BID PACKAGE 02 – ADDENDUM 06

Re: Wilma P Mankiller Health Center Expansion

From: James R Childers Architect, Inc.
45 South 4th Street
Fort Smith, Arkansas 72901

SUBSTITUTION REQUEST (After the Bidding Phase)

Panel Hinge

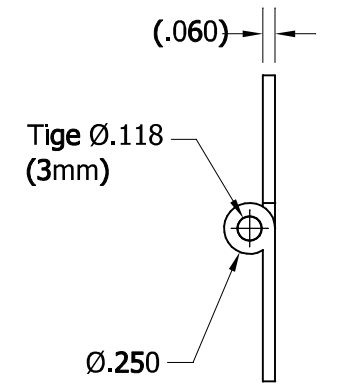
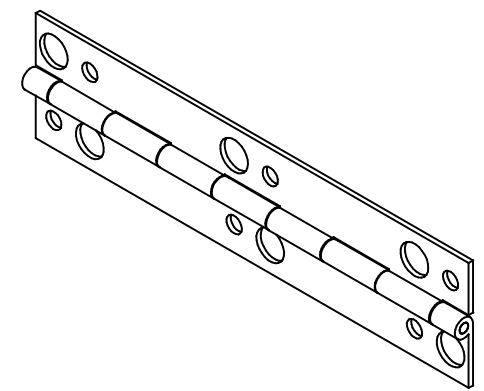
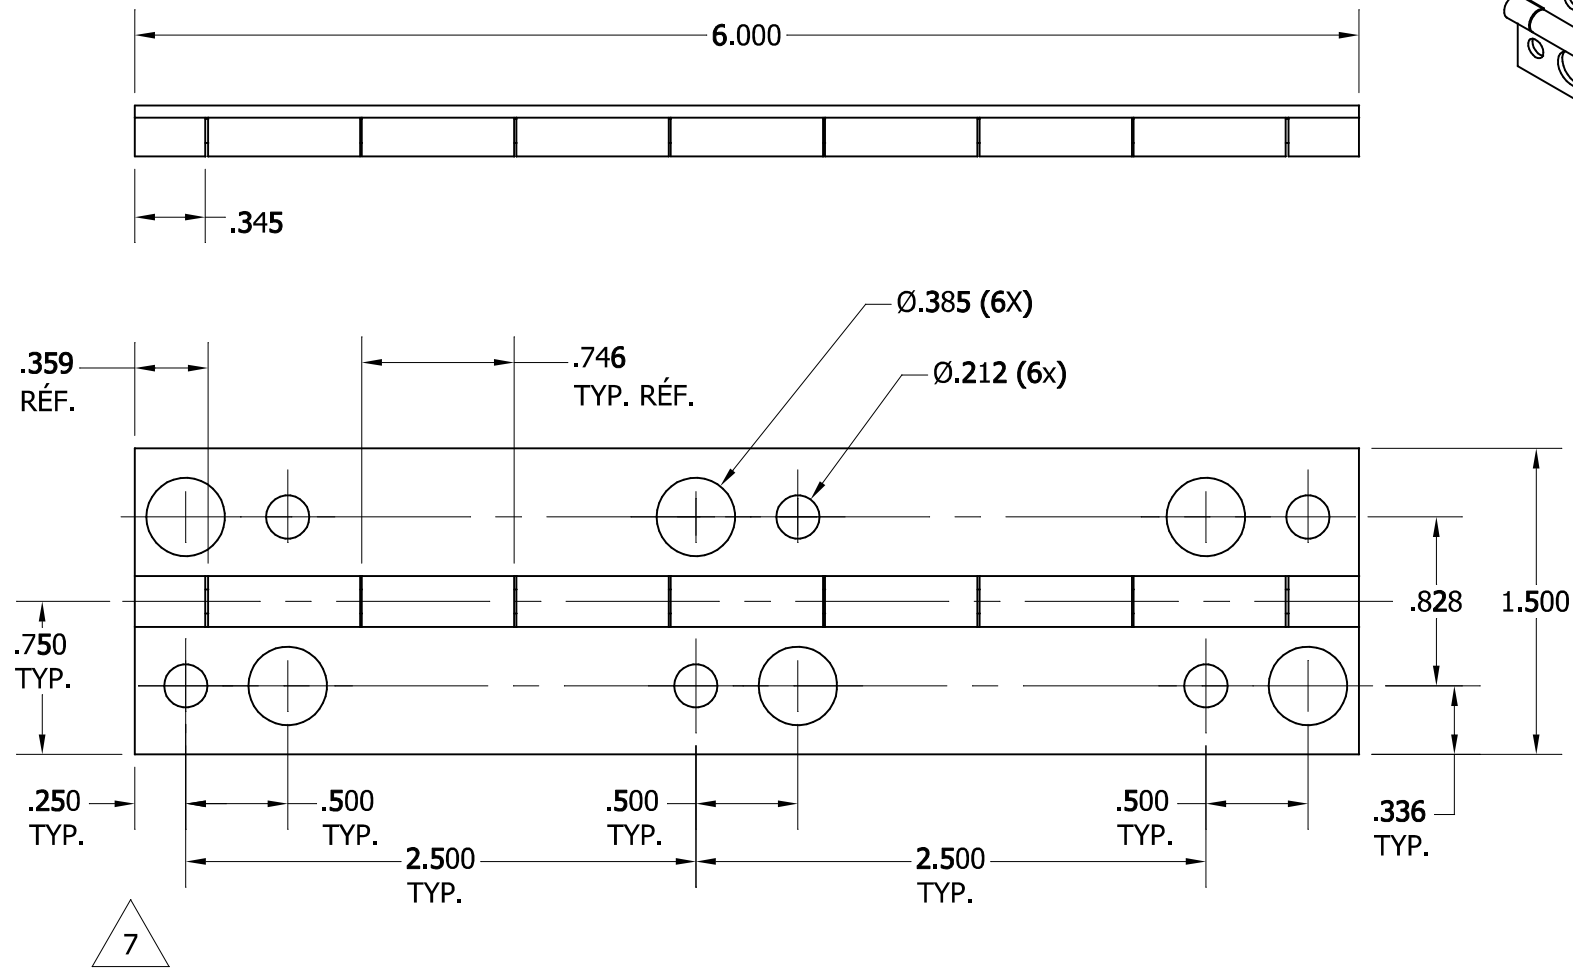
Differences between proposed substitution and specified product: Piano hinges projecting 1/4" from panel face

Contractor / Subcontractor to coordinate necessary opening / clearance requirements per manufacturer's recommendations.
Provide required adjustments for Architect's review and approval prior to installation.
